Access Compliance Report Public Rights-of-Way (Pedestrian Signals)

Main Street: CROWN_VALLEY_PKWY Cross Street: ANTONIO_PKWY Location: S

ADA ID: SGRK211022140447 Signal Type: One Push Button-Non APS Overall Compliance: No Severity Scores: BTN 1: 35 BTN 2: N/A No BTN: N/A

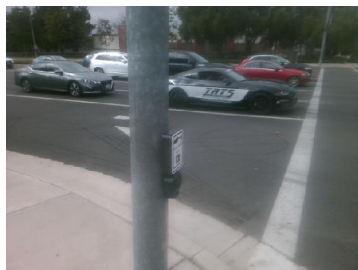
Compliance	Description	Data	Compliance	Description	Data
Button Count	Button1	Yes	Distant to Additional Button (in)	285	
Additional Button Present?	Yes	N/A	Additional Button ID	SGRK211022140726	
Located In An Island/Median?	No				
N/A B 1 Sign Present?	Yes	N/A	B 2 Sign Present?	N/A	
Yes B 1 Sign Purpose?	Yes	N/A	B 2 Sign Purpose?	N/A	
Yes B 1 Sign Lettering & Contrast?	Yes	N/A	B 2 Sign Lettering & Contrast?	N/A	
Yes B 1 Parallel To XWalk?	Yes	N/A	B 2 Parallel To XWalk?	N/A	
N/A B 1 PAR to Button?	N/A	N/A	B 2 PAR to Button?	N/A	
N/A B 1 PAR to XWalk?	N/A	N/A	B 2 PAR to XWalk?	N/A	
Yes B 1 Clear Floor Space?	Yes	N/A	B 2 Clear Floor Space?	N/A	
N/A B 1 FWD Approach?	N/A	N/A	B 2 FWD Approach?	N/A	
N/A B 1 FWD Approach Constrained?	N/A	N/A	B 2 FWD Approach Constrained?	N/A	
N/A B 1 FWD Approach Reach (in)	N/A	N/A	B 2 FWD Approach Reach (in)	N/A	
N/A B 1 FWD Approach Width (in)	N/A	N/A	B 2 FWD Approach Width (in)	N/A

N/A B 1 FWD Approach Obstruction?	N/A	N/A	B 2 FWD Approach Obstruction?	N/A	
N/A B 1 FWD Approach Obstruction Dist (in)	N/A	N/A	B 2 FWD Approach ObstructionDist (in)	N/A	
N/A B 1 PARA Approach?	N/A	N/A	B 2 PARA Approach?	N/A	
N/A B 1 PARA Approach Constrained?	No	N/A	B 2 PARA Approach Constrained?	N/A	
Yes B 1 PARA Approach Reach (in)	0	N/A	B 2 PARA Approach Reach (in)	N/A	
N/A B 1 PARA Approach Width (in)	N/A	N/A	B 2 PARA Approach Width (in)	N/A	
N/A B 1 PARA Approach Obstruction?	No	N/A	B 2 PARA Approach Obstruction?	N/A	
N/A B 1 PARA Approach Obstruction Dist (in)	N/A	N/A	B 2 PARA Approach Obstruction Dist (in)	N/A	
No B 1 Clear Floor Space Slope (%)	4.1	N/A	B 2 Clear Floor Space Slope (%)	N/A	
Yes B 1 Clear Floor Space XSlope (%)	1.5	N/A	B 2 Clear Floor Space XSlope (%)	N/A	
N/A B 1 PAR Slope (%)	1.6	N/A	B 2 PAR Slope (%)	N/A	
Yes B 1 Height (in)	40	N/A	B 2 Height (in)	N/A	
Yes B 1 Pressure (#)	5	N/A	B 2 Pressure (#)	N/A

Possible Solutions: Replace Signal Push Button With APS Button. Remove and Replace Clear Space.
